Asian Renewable Energy Hub

Response to Submissions on Environmental Review Document

Assessment Number 2140

November 2019

Figure 1.1: Locations of all types of flora sampling sites relative to the range of vegetation types present within the development envelope and the conceptual design clearing footprint.

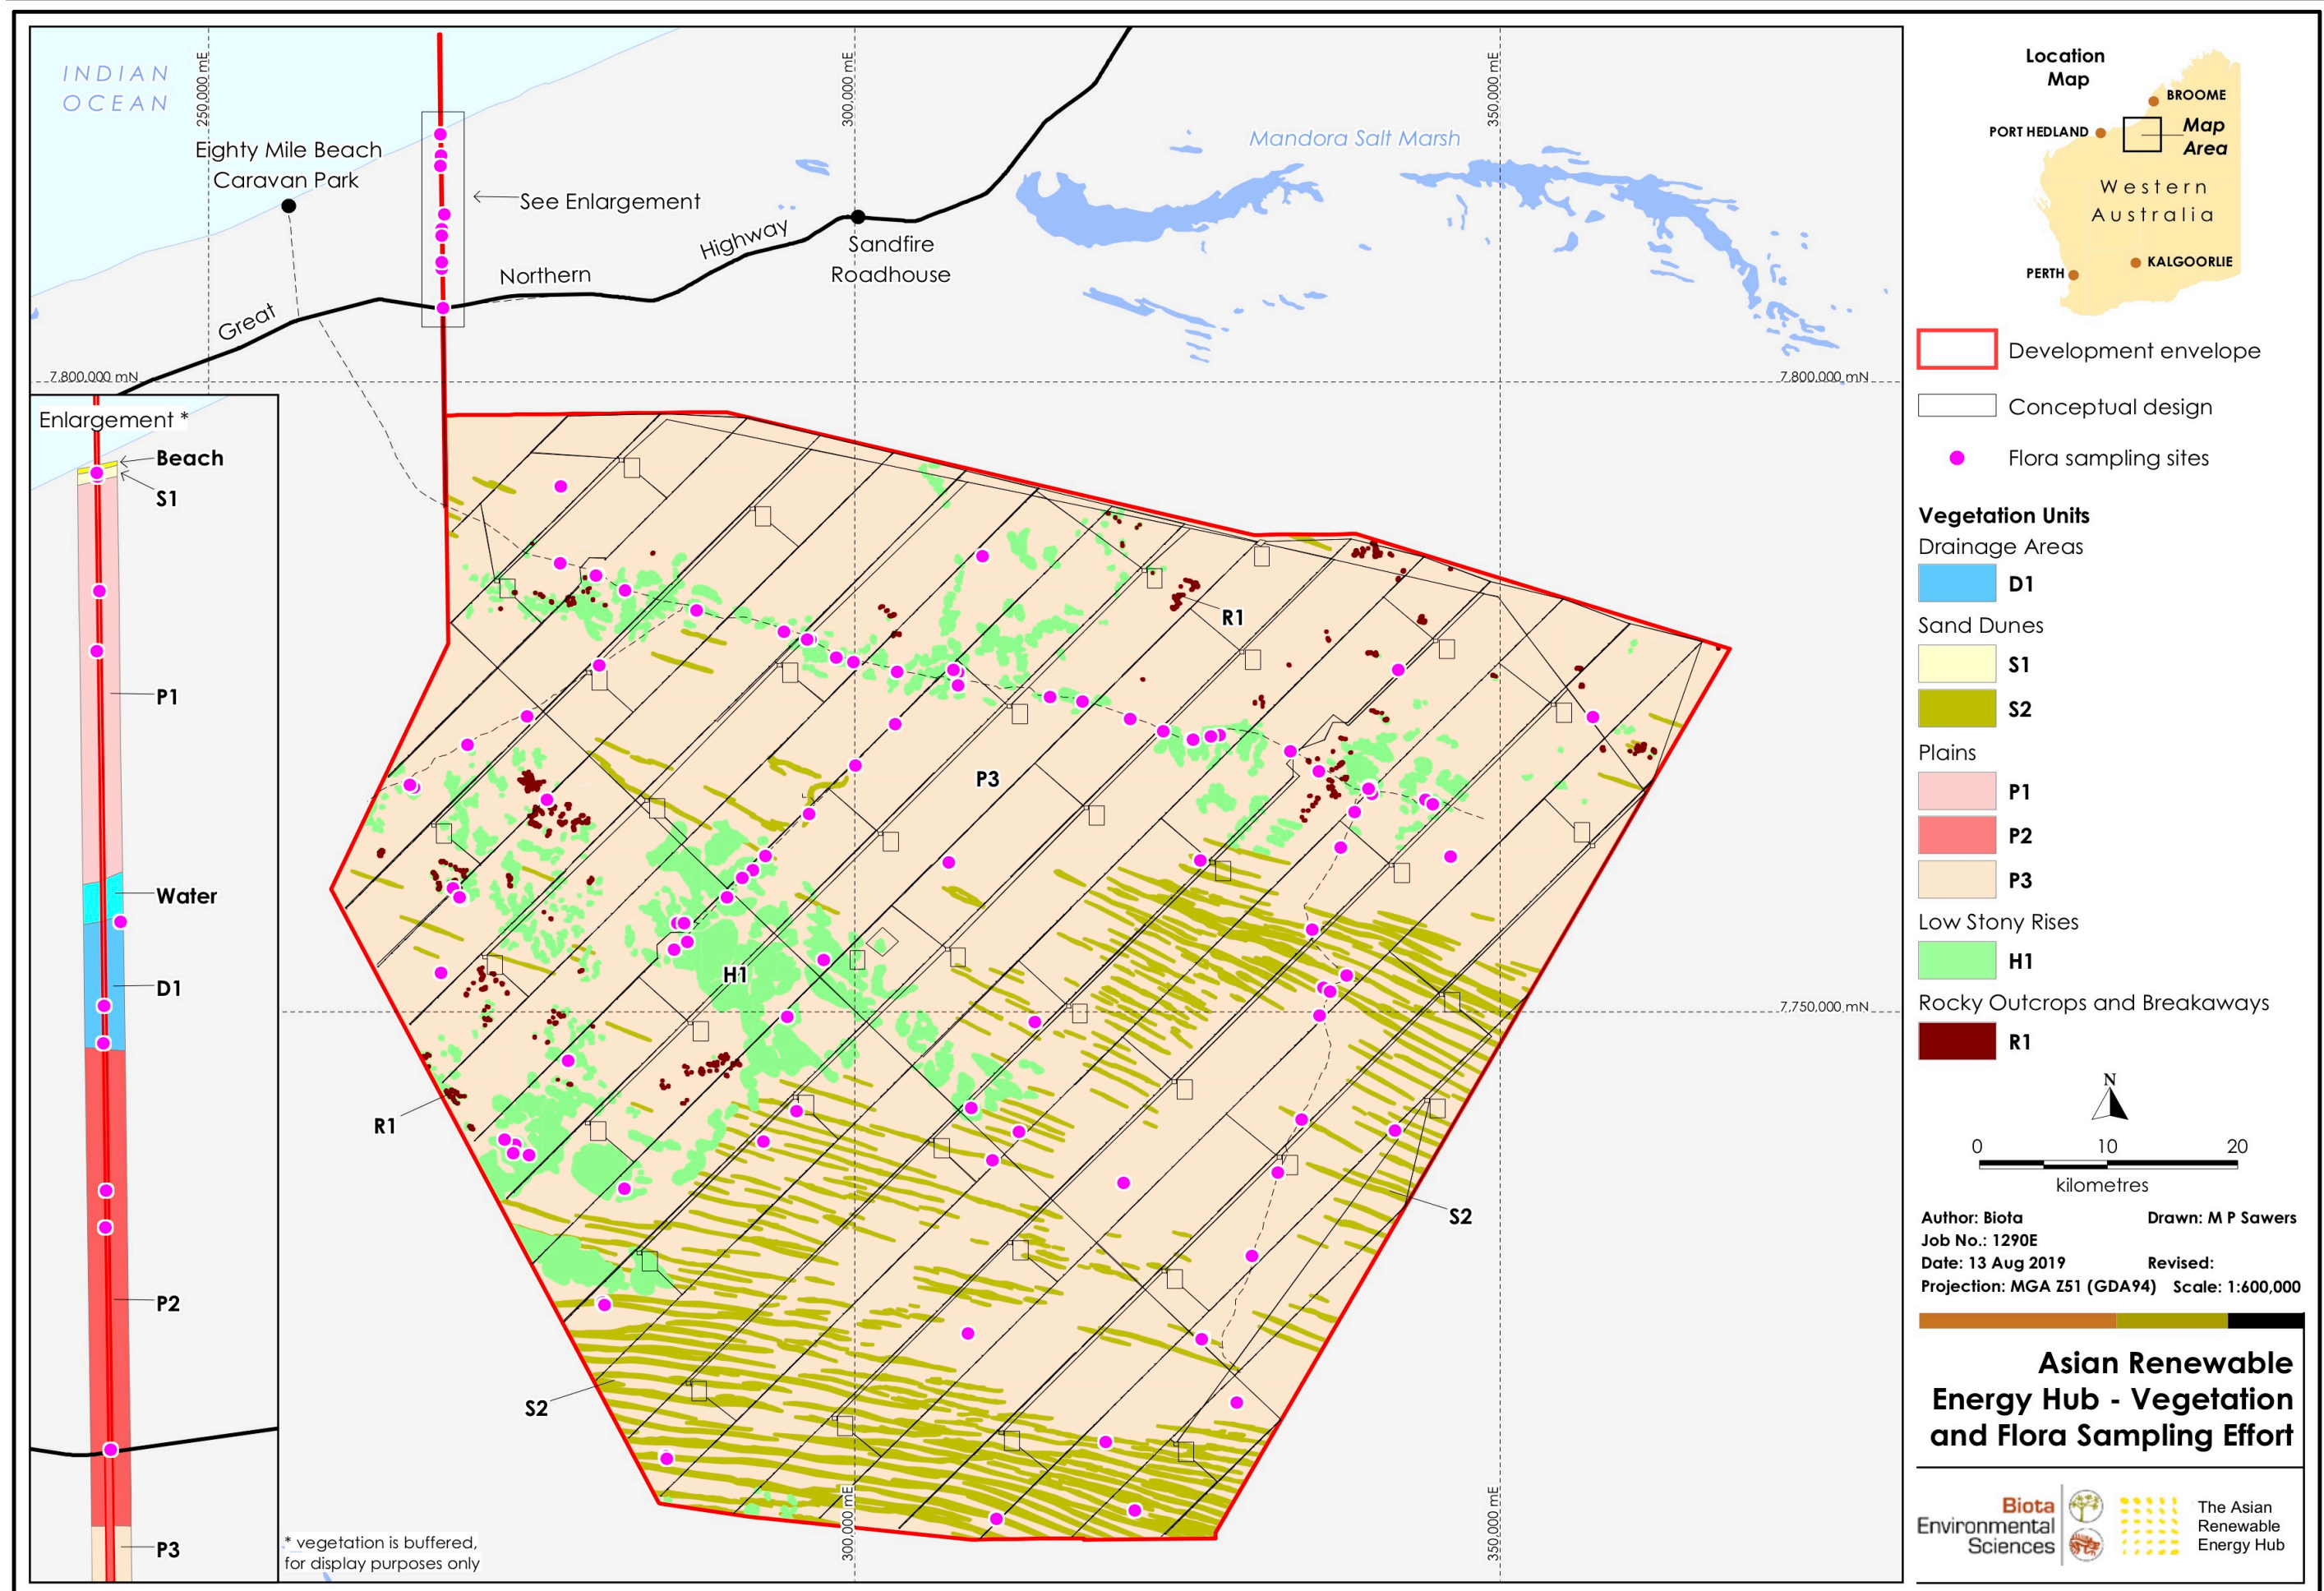
DWER F&V 2 Prop Rts 4.16	DWER	<p>In regards to flora species:</p> <p>The current footprint does not directly impact upon any known locations of the Priority 1 species <i>Seringia exastia</i> (or collections of <i>Seringia</i> that could not be identified to species level) or the location of the Priority 1 taxon <i>Tephrosia rosea</i> sp. Port Hedland. The mitigation measures on p. 150 of the ERD state that further targeted survey will take place in the detailed design phase and that direct impact on all locations of these species will be avoided.</p> <p>The ERD does not quantify the impacts on the seven Priority 3 species identified through the flora survey, so impact assessment on these species is not possible. The mitigation measures on p. 150 of the ERD state that further targeted survey will take place in the detailed design phase and that direct impact on all locations of these species will be avoided where possible.</p> <p>Table 6.4 of the Flora and Vegetation survey report lists five taxa that warrant further resolution. The ERD does not include reference to these taxa or information on whether or not they are likely to be impacted upon by the proposal.</p> <p>Please confirm the approach, timing, and management and mitigation actions to ensure adequate flora and vegetation data will be used to inform proposal design and to ensure the EPA’s objective for Flora and Vegetation will be met.</p>	<p>The proponent notes that <i>Seringia exastia</i> is actually listed as Threatened, not Priority 1, but agrees that the current conceptual design does not impact on the known populations of either that species or <i>Tephrosia rosea</i> sp. Port Hedland, and that the mitigation measures committed to are as reiterated in this submission.</p> <p>However, since the release of the ERD, it has been confirmed with Dr Carol Wilkins (the taxonomist who described <i>Seringia exastia</i>) that a paper has been accepted for publication that synonymises this species with the widespread and not threatened <i>S. elliptica</i>, with <i>S. exastia</i> remaining the widespread species’ name, as it was the first described (C. Wilkins, DBCA, pers. comm. 2019). This will mean that <i>S. exastia</i> will no longer be a threatened species, and not of conservation significance, and any clearing impacts will no longer require mitigation through project design.</p> <p>Regarding the Priority 3 taxa, as detailed in Section 6.2 of Appendix 5 of the ERD, all seven species are, on the basis of recent survey data, far more widespread and commonly collected than previously thought when initially listed as Priority flora (this is also summarised on p148-149 of the ERD itself).</p> <p>An illustrative example is <i>Bonamia oblongifolia</i> (Priority 3), which as Appendix 5 details, has been recorded from locations spanning more than 460 km, including a recent new population estimated at over a million plants, suggesting it probably does not warrant continued listing as a Priority species. <i>Seringia katatona</i> (Priority 3) also now has records covering a similar extent from numerous new locations, including populations of thousands of plants, and even the original description notes: ‘<i>given the extent of unexplored suitable habitat among the [then] known localities, the species is most likely not under threat...</i>’ (see Appendix 4 of the ERD).</p> <p>Given this wider context for the Priority 3 species, that the new development envelope records are additional to the previously known ones, and that the final design will be modified where practicable to avoid impacts anyway, quantification of local impacts is not necessary to be able to conclude that the regional conservation status of these species would not be altered by the proposal.</p>
